Entergy Operations, Inc.
1448 S.R. 333
Russellville, AR 72801
Tel 501 858-5000

February 25, 2000

1CAN020007

Subject: Arkansas Nuclear One - Unit 1
Docket No. 50-313
License No. DPR-51
Supplemental Information for Alternative Code Repair of Hot Leg Nozzle RC-1071/1072

FIGURE 9-1
FINITE ELEMENT MODEL OF REPAIR DESIGN

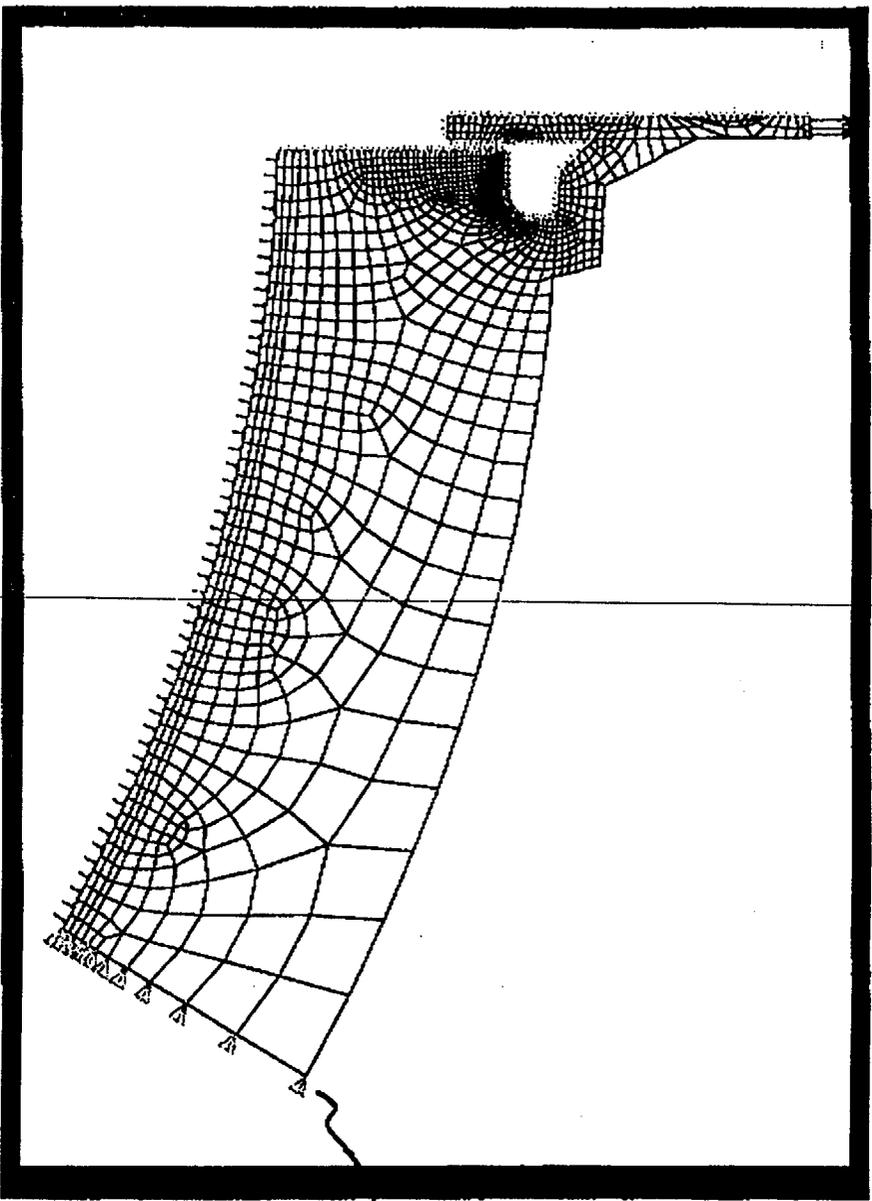
ANO Response: Enclosure 2 is a letter from Framatome Technologies dated February 24, 2000 (FTI-00-512) that provides a summary of the weld pad overlay repair. This also includes two diagrams showing the mesh of the finite element model.

- a) The structural analysis is performed using the finite element method (using the ANSYS FE program)
- b) An axisymmetric analytical model is employed – including Hot Leg Pipe, cladding, nozzle, original J-groove/fillet configuration and the repair weld pad/fillet welds

- c) The Hot Leg Pipe is modeled as a spherical segment with adjusted (increased) pressure to conservatively simulate the stress levels in the Hot Leg elbow

- d) The pressure is applied to all internal surfaces including the perimeter of the original welds (i.e., effectively the original welds are considered as non-existent or void)

- e) No structural strength is credited to the original J-groove/fillet welds
- f) Both the run pipe (Hot Leg elbow) moments and branch pipe (Level Tap Nozzle) loads are conservatively applied to the FE model in conjunction with the internal pressure

Assumed Elbow Flaw Indication at the Level Tap Nozzle

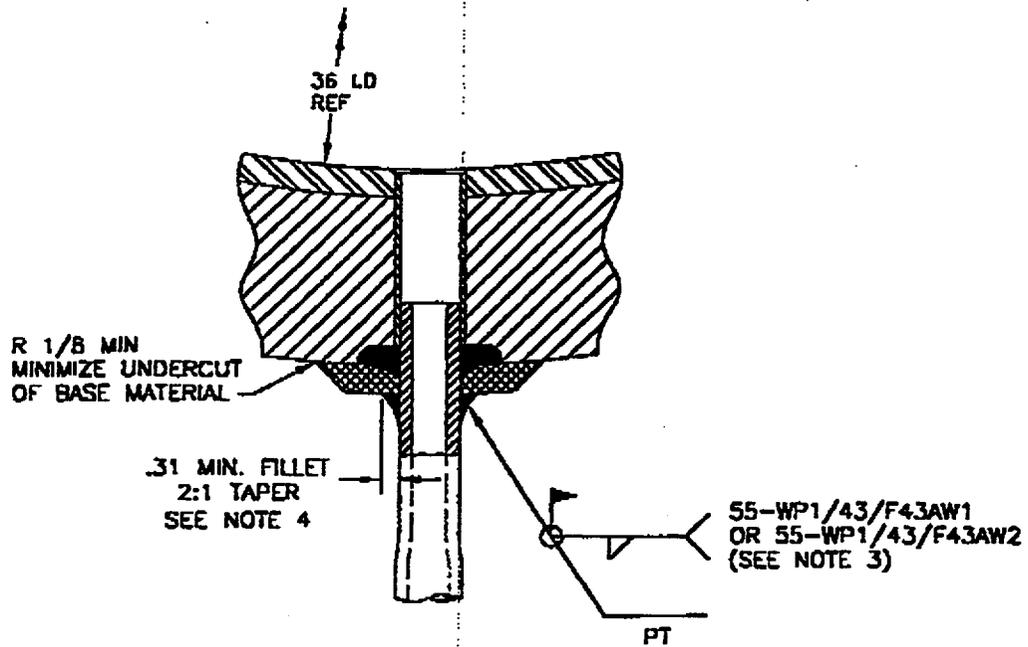
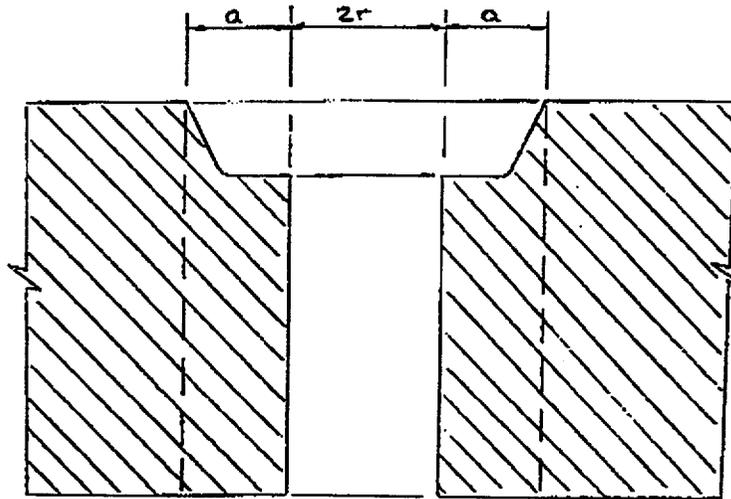
NRC Question 5: Provide sketches and qualitative discussion of the assumed flaws that were used for interaction with the base metal and for the new weld pad repair.

The elbow flaw is assumed to fill a 5/8" x 0.916" J-groove shaped weld prep:

For the elbow evaluation, the flaw is treated as a surface flaw, and is conservatively modeled as two symmetric cracks, radial with respect to the elbow penetration, and extending through the entire thickness of the elbow. Flaw growth is in a radial direction relative to the penetration, or parallel to the surface of the elbow:
